**PR/0603/22**

## Record of Executive Business and Chief Executive's Order

**Reg. Reference:** SD21A/0329      **Application Date:** 01-Dec-2021  
**Submission Type:** Additional Information      **Registration Date:** 19-Apr-2022

**Proposed Development:** Development comprising 189sq.m of warehouse space and 89sq.m of ancillary office space.

- 3. See drawing no ZF11/P04 for details of the proposed new railings along the Bluebell Avenue Boundary.**

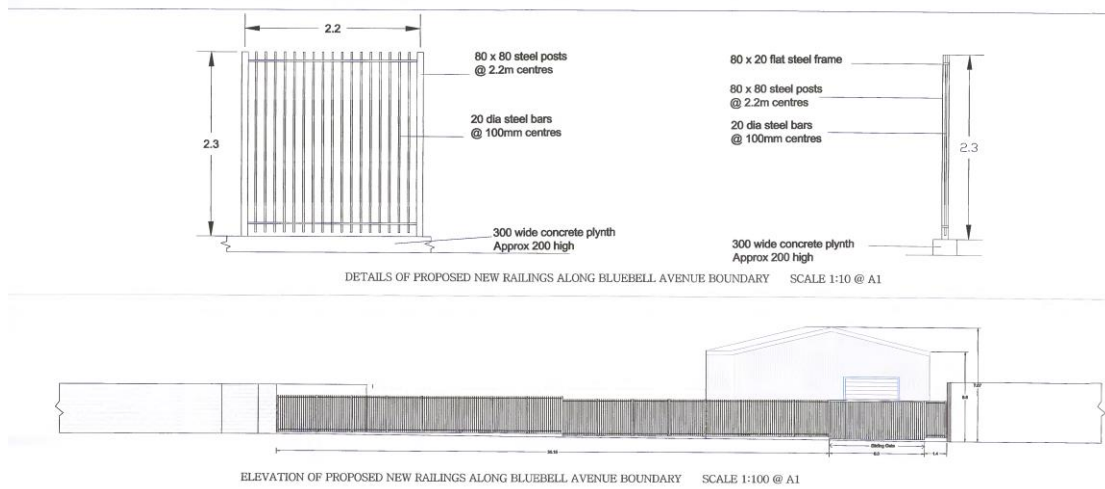
A drawing showing the proposed railing boundary treatment (2.3m high set on top of a 200mm high concrete plinth) can be seen below and is considered to be satisfactory to the Planning Authority.

The Planning Authority Considers the applicant has satisfactorily addressed the request for Additional Information for this item.
